## **NOTIFICATION**

#0016 Rev 1

**SUBJECT:** Ballistic Parachute "Blowout" Skin Inspection and Installation

**MODELS AFFECTED:** All Sling 4 and Sling 4 TSi aircraft with parachutes installed / to be installed

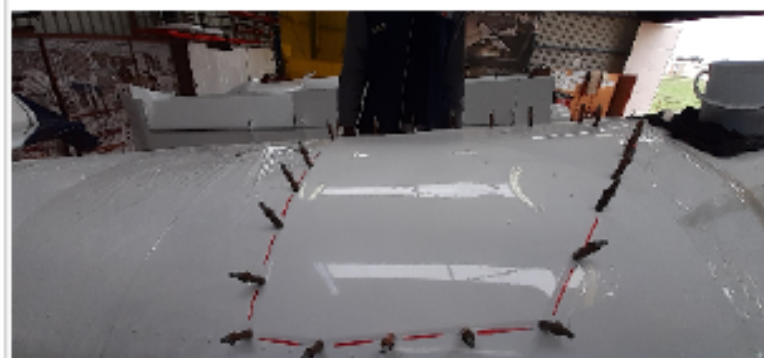
- As shown in the simplified section view below, ensure that the silicone completely seals the skin and reaches up to the leading edge of the parachute skin, preventing any air entering underneath the skin

- Ensure an airtight seal to prevent water and/or air ingress.
  - Make sure the silicone reaches all the way out to the outer edge of the parachute skin, particularly at the leading edge facing the airflow.

## PARACHUTE BLOWOUT SKIN INSTALLATION

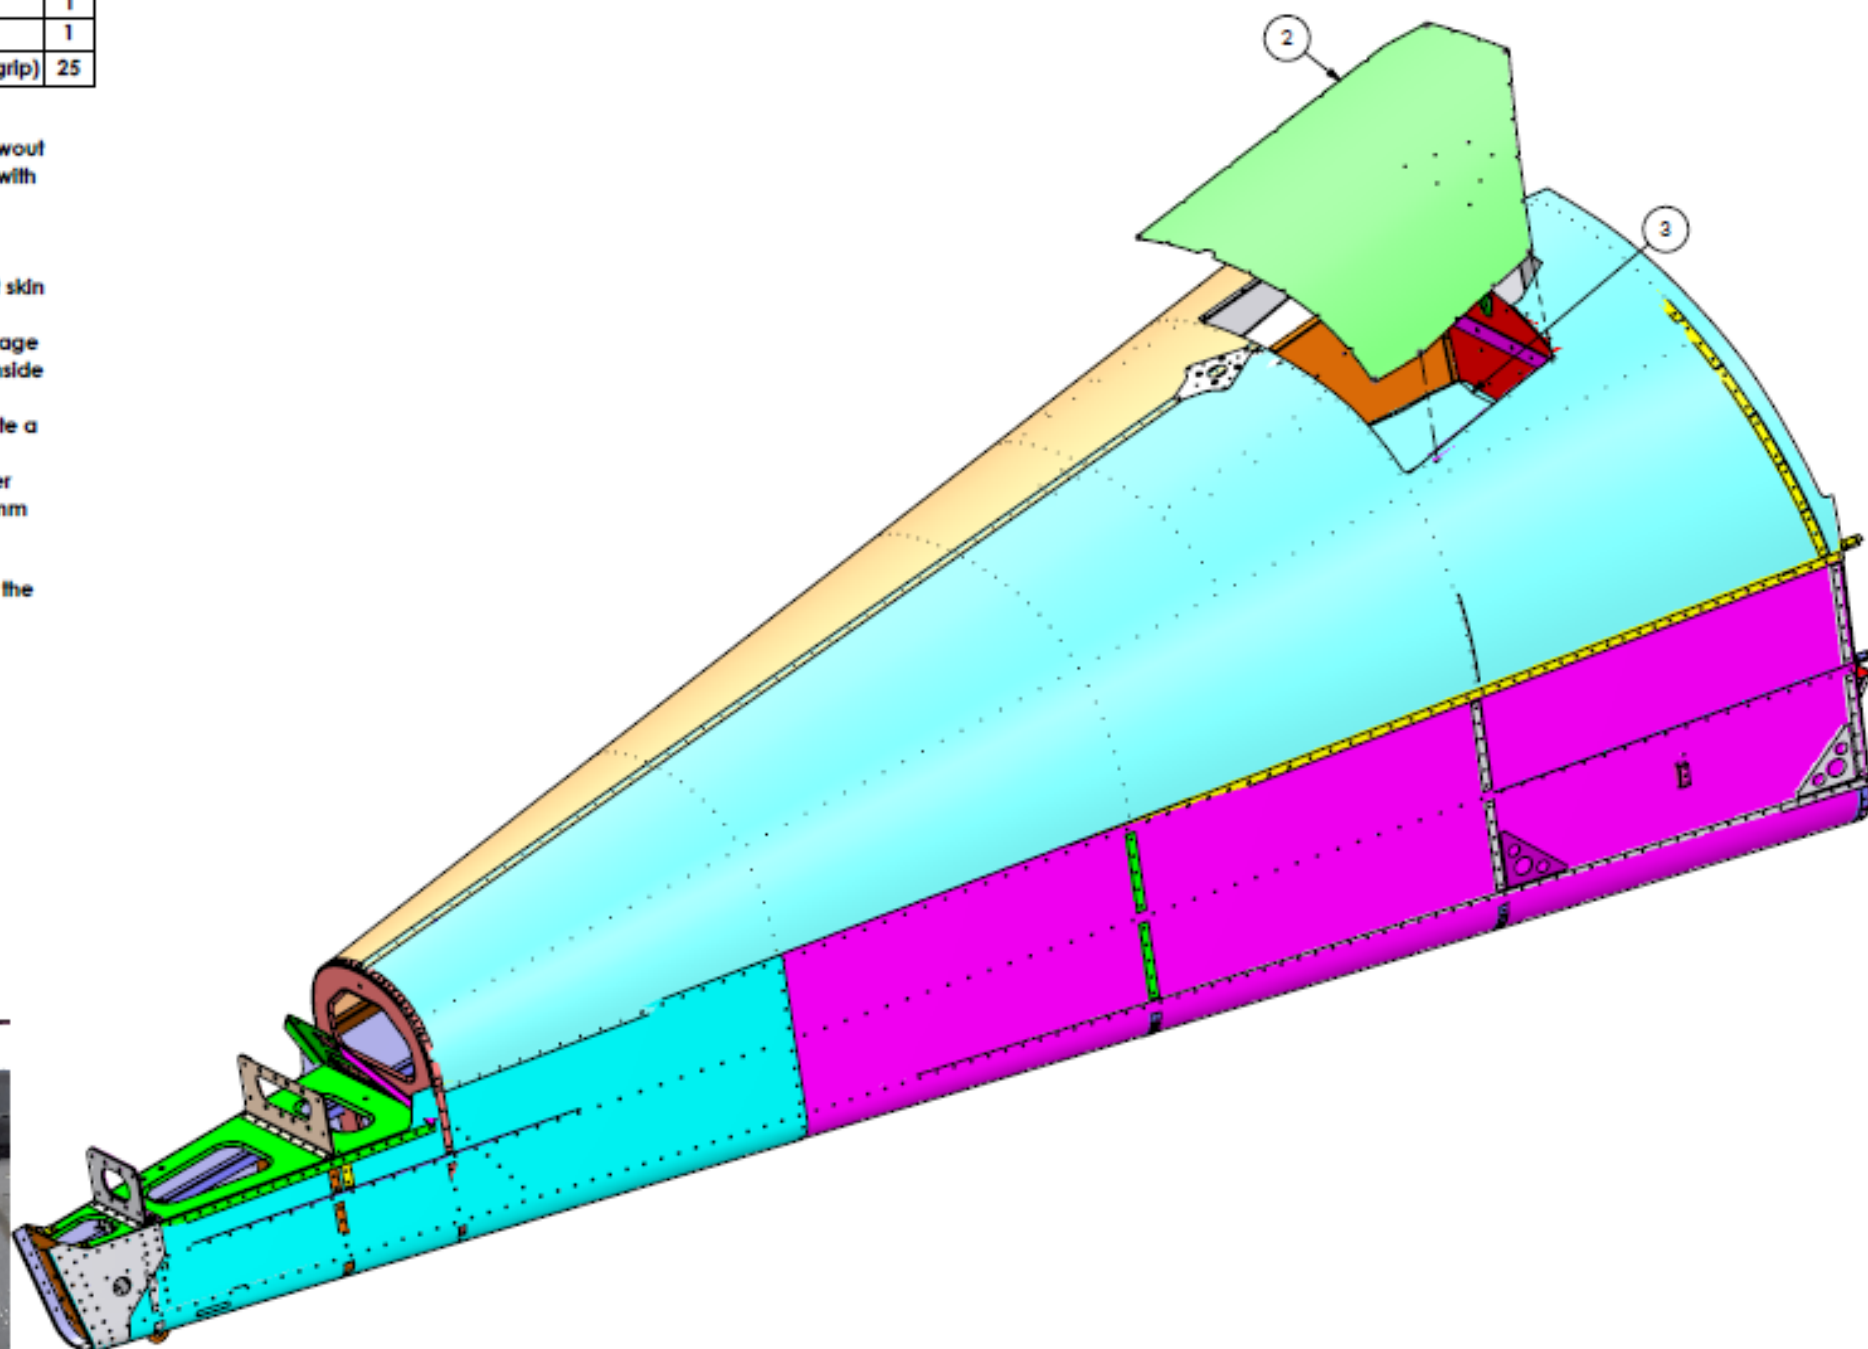
- When installing the blow-off skin:
  - Use the correct rivets (HW-RIV-142-X-X), a 3.2 x 8mm aluminium, multi-grip, dome head rivet with steel mandrel.

- Make sure not to oval the holes when drilling into the fuselage skin.
  - Keep a consistent gap around the blowoff skin using the feeler gauge as per installation instructions.

1. Align the Blowout skin with the Rear Fuselage and ensure that the Blowout skin covers the Parachute compartment and no cables are interfering with the skin.

2. Use masking tape to keep the Blowout skin in place.
3. Mark and drill 3.2mm holes into the Rear Fuselage.
4. Cleco the Blowout skin onto the Rear Fuselage and trace the Blowout skin onto the Rear Fuselage. Then remove the Blowout skin.

5. Apply PVA release agent onto the Blowout skin where the Rear Fuselage and Blowout skin will make contact. Apply PVA release agent on the inside of the traced area of the Rear Fuselage as well. Leave to dry.

6. Apply silicone inside of the traced area on the Rear Fuselage to create a gasket.
7. Install the Blowout skin by using a 0.4mm feeler gauge or shim spacer between the Rear Fuselage and the Blowout skin when riveting 3.2 x 8mm rivets. This will create a water tight seal and also removable when deploying the Parachute.
